Jabiru Service Letter: Cylinder Head Inspection			JABIRU AIRCRAFT PTY LTD P.O. Box 5792 Bundaberg West Queensland, Australia. Phone:+61 7 4155 1778 Fax:+61 7 4155 2669 Web: www.jabiru.net.au Email: info@jabiru.net.au		
JSL 014-4	Release Date: 1 st July 2016	Effective Date: 8 th July 2016	Affected Models: See Applicability	S/No. Range: See Applicability	Page 2 of 17

LSA Service Notification: JSN 014-4

Subject: Jabiru Cylinder Head Inspection

Figure 4 - New double valve spring vs the previous single spring configuration

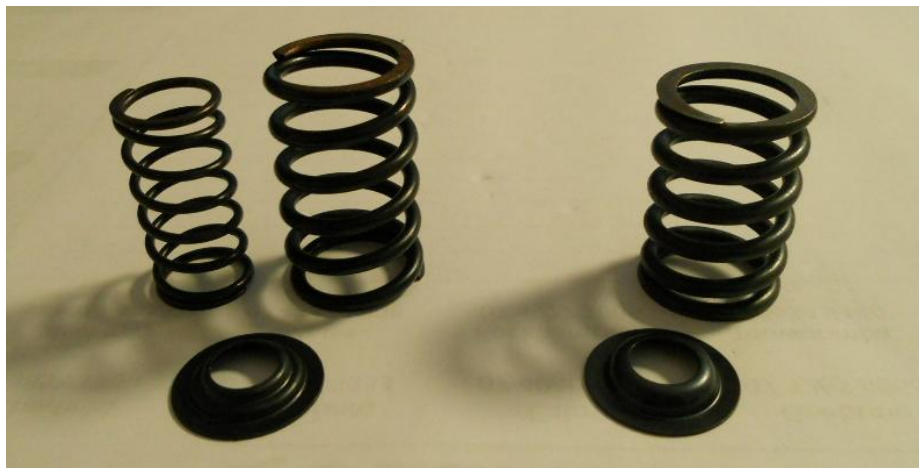
- After substantial design work and testing Jabiru Aircraft has released a configuration upgrade to the valve train. The double valve spring assembly.
- The double valve spring assembly features a small inner spring inside a larger outer spring, the coils are wound in opposite directions to prevent coil binding.

- The valve seated pressure (i.e. valve closed pressure) is greater than for the single valve spring which can improve valve sealing. This can help prevent problems with compression and valve leakage which may contribute to preventing a valve failure. With a second spring there is now an element of redundancy in the system.
- Double Valve springs can be retrofitted into all Jabiru 2200 and 3300 engines. This upgrade is highly recommended for all engines.
- Upon inspection even if the condition of valves, springs or washers does not necessitate replacement, it is highly recommended that the double valve spring system be installed while cylinder heads are off the engine. In upgrading to double valve springs the following items must be replaced:

- Inner and Outer Valve Springs – replaces the existing single valve spring. **Do not install only the outer spring.**
- Bottom spring washer – The double valve spring assembly requires a specially stepped bottom spring washer with lands for both springs. Double valve springs should not be installed with the existing single spring washer.

- Top spring washer, collets and valves – Similarly the double valve spring assembly requires a special double stepped top spring washer. Since the top spring washer is being replaced the collets and valves themselves must also be replaced with pre-fitted hardware kits. The valves, collets and double land top/bottom spring washers are provided in the double spring inlet and exhaust valve kits.

- When upgrading to double valve springs. The springs (and other items listed above) must be replaced on all cylinder heads (both inlet and exhaust valves) at the same time. **An engine cannot have a mixture of single and double valve springs.**
